SUBJECT: REVIEW OF PEACH BOTTOM UNIT 2 JUSTIFICATION  
FOR CONTINUED OPERATION (TACS #55606, #55576,  
AND #55174)

SUBJECT: CRACKING IN SEGMENT OF CORE SPRAY PIPING, PEACH BOTTOM ATOMIC POWER STATION (PBAPS), UNIT 3 (TAC NO. M88098)

**10CFR50.59 REVIEW for MODIFICATION P00335  
INSTALLATION of CORE SPRAY LINE DOWNCOMER CLAMPS  
in Peach Bottom Atomic Power Station Unit 3**

CORE SPRAY LINE DOWNCOMER BRACKET  
STRESS ASSESSMENT REPORT  
for  
PEACH BOTTOM ATOMIC POWER STATION, UNIT 3  
Modification P00335

Figure 1. Core Spray Sparger Riser/Downcomer

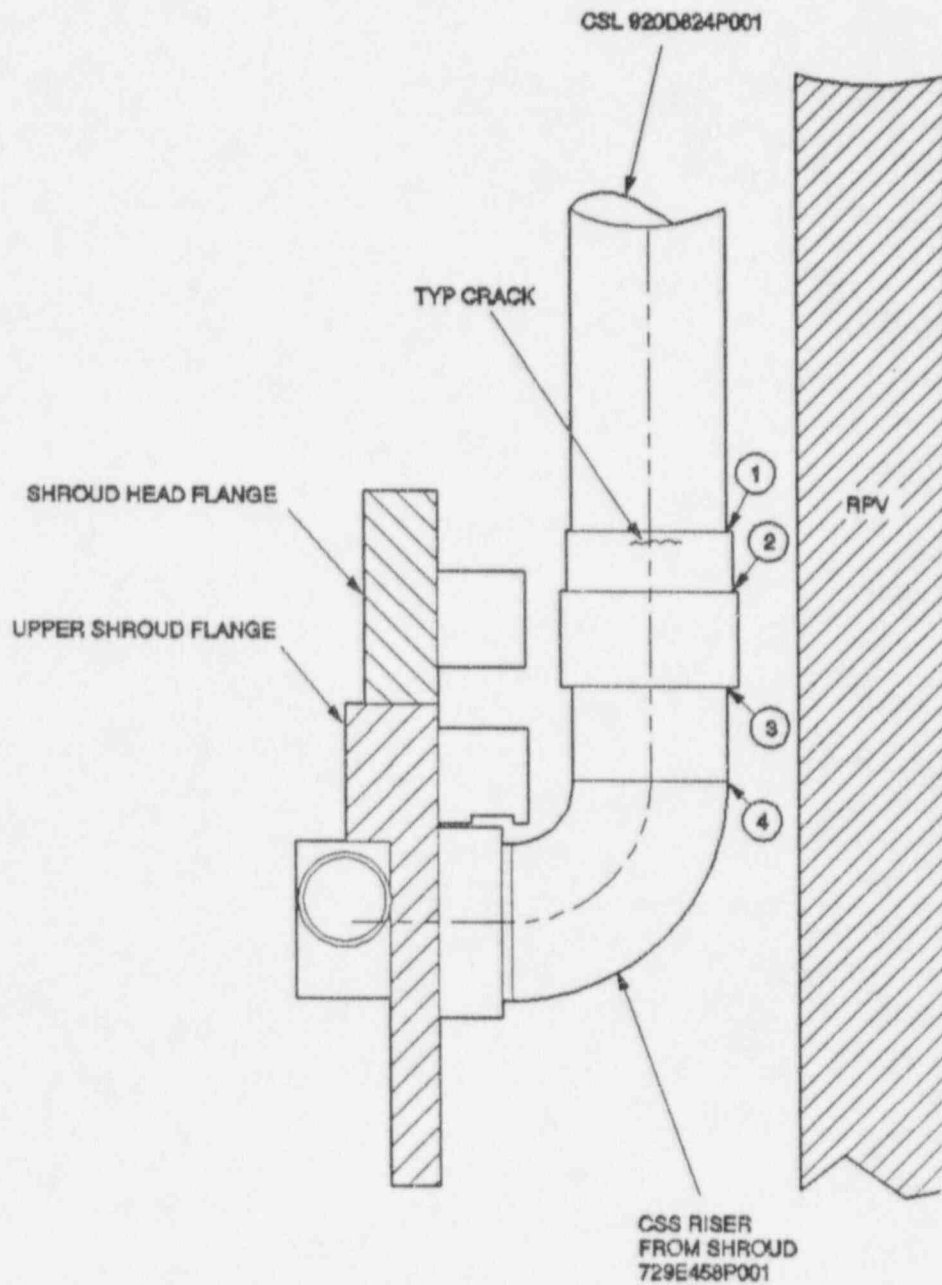
A repair by modification was designed that addresses the identified crack indications (below weld 1, Figure 1) on the 7.5 degree, 172.5 degree, 187.5 degree and 352.5 degree azimuths. The repair at 172.5 degree azimuth also envelops welds 2, 3 & 4 of Figure 1. The additional design features for the 172.5 azimuth clamp were included prior to 3R10 in vessel inspections to envelop weld locations associated with the downcomer repair on a contingency basis.

No. Systems and components used to mitigate the (radiological) consequences of the accidents in the UFSAR are not degraded by this modification. All of the events in the Peach Bottom UFSAR were examined to determine if the consequences of any of these events is increased by the installation of the repair clamps. Consequences (i.e., radiological dose) associated with the design basis accidents are evaluated in the UFSAR. The existing core spray downcomer and repair clamps do not function to mitigate the consequences of any UFSAR event except the design basis LOCA event. No UFSAR dose calculation will be impacted by this change. For the design basis LOCA event discussed in the UFSAR, the core spray line and downcomer provide the flow path inside the RPV for the ECCS flow to the core spray spargers. Maintaining this flow path is required to ensure that core cooling capability is maintained following the design basis LOCA. This repair design, through its restraint of the joint, ensures the integrity of the core spray downcomer, with a 360 degree through wall crack in the pipe sleeve, under DBA conditions. The modification will also ensure the structural integrity of the 'D' downcomer in the event additional full circumferential cracking develops at weld locations 2 through 4 of Figure 1.

Figure 1A Core Spray Line Finite Element Model (Nodal and Element)

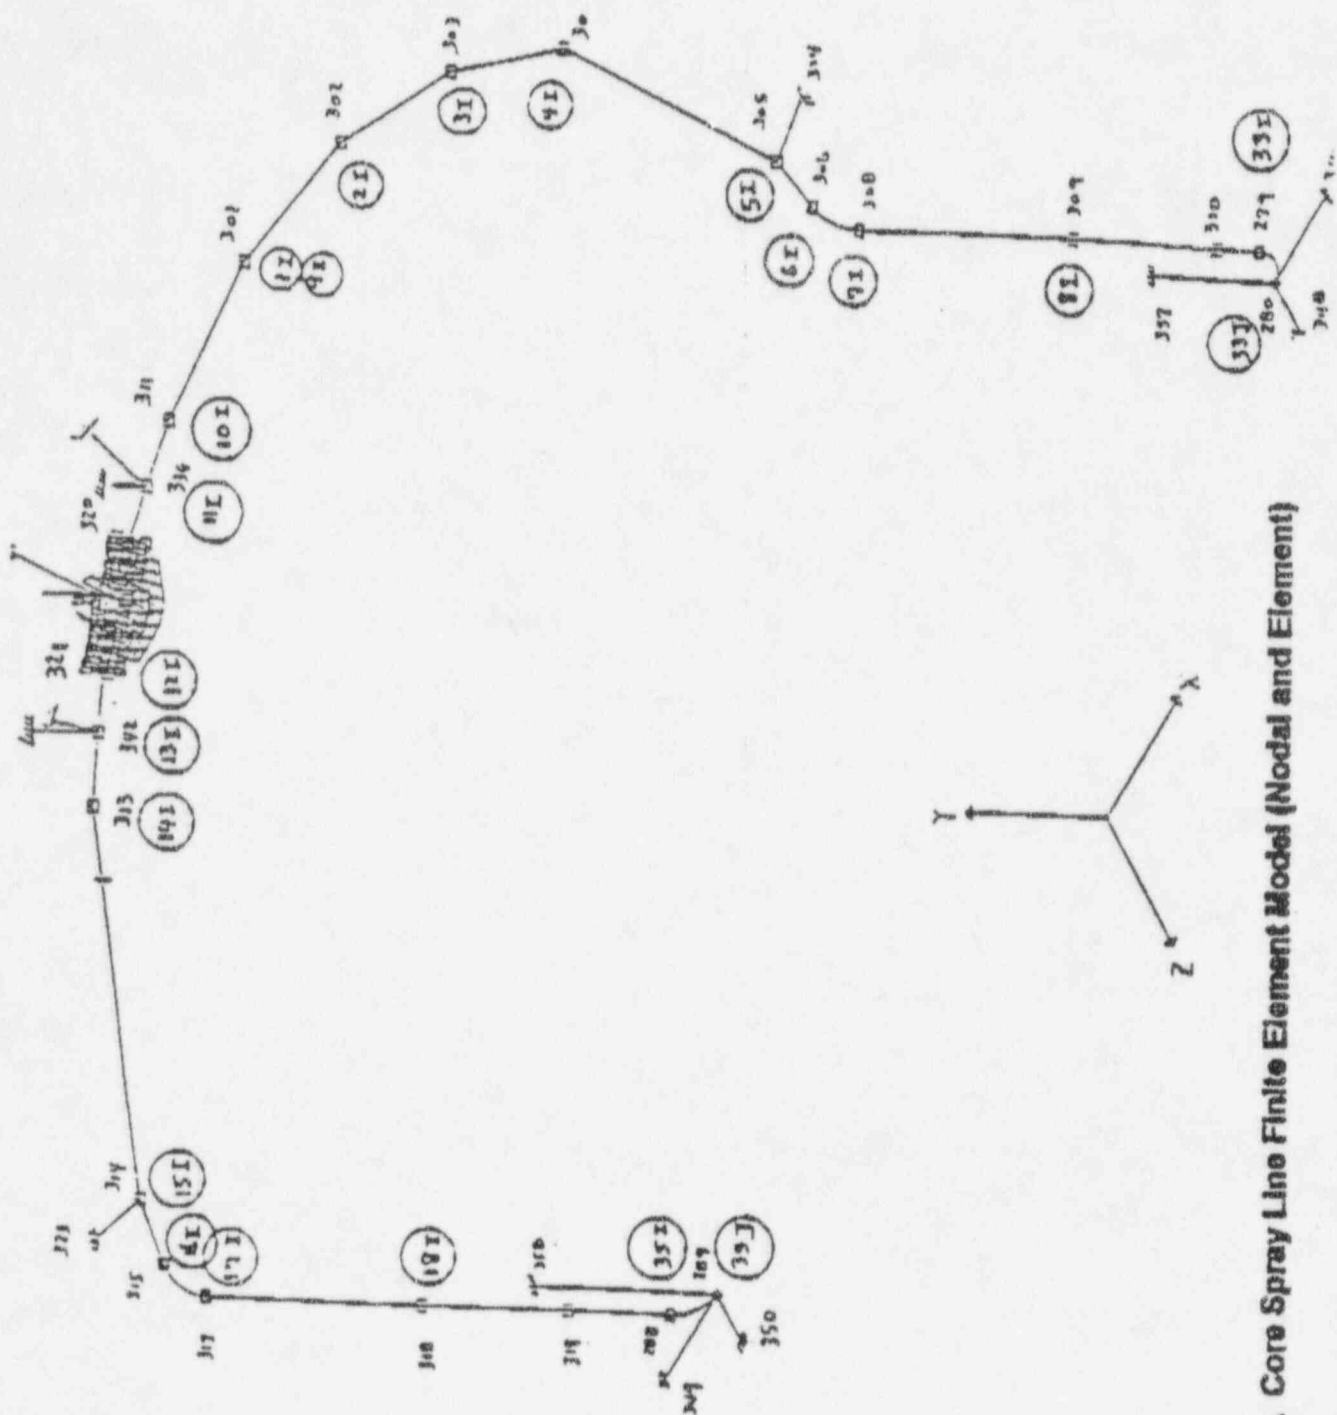
Provide the development of the loads during normal operation and postulated accident conditions that were used to establish the structural integrity of the Core Spray Line (CSL) clamp design at Peach Bottom Atomic Power Station (PBAPS) Unit 3.

The loads applied to the finite element model (FEM) were obtained from the analysis of the core spray pipe. The core spray model is provided in Figure 1A of GENE-771-98-0295, Rev. 2. The CSL was modeled in conjunction with the core spray nozzle thermal sleeve, the T-box, and the reinforcement bracket to the pipe support joint just before the shroud penetration location.

The analysis included the cases as (1) design condition (no crack) and (2) with full separation of the CSL and T-box. To simulate the separation condition, all the plate elements, 360 degree circumference, between the T-box and the core spray pipe, before the weld of the bracket, are assigned with negligible Young modulus. The model has also considered that the downcomer has cracked and is tied together by a link at the location of the clamp modification. The force can be transferred through the joint, but the moment is released. Weight of the linkage (300lb) was included in the analysis model.
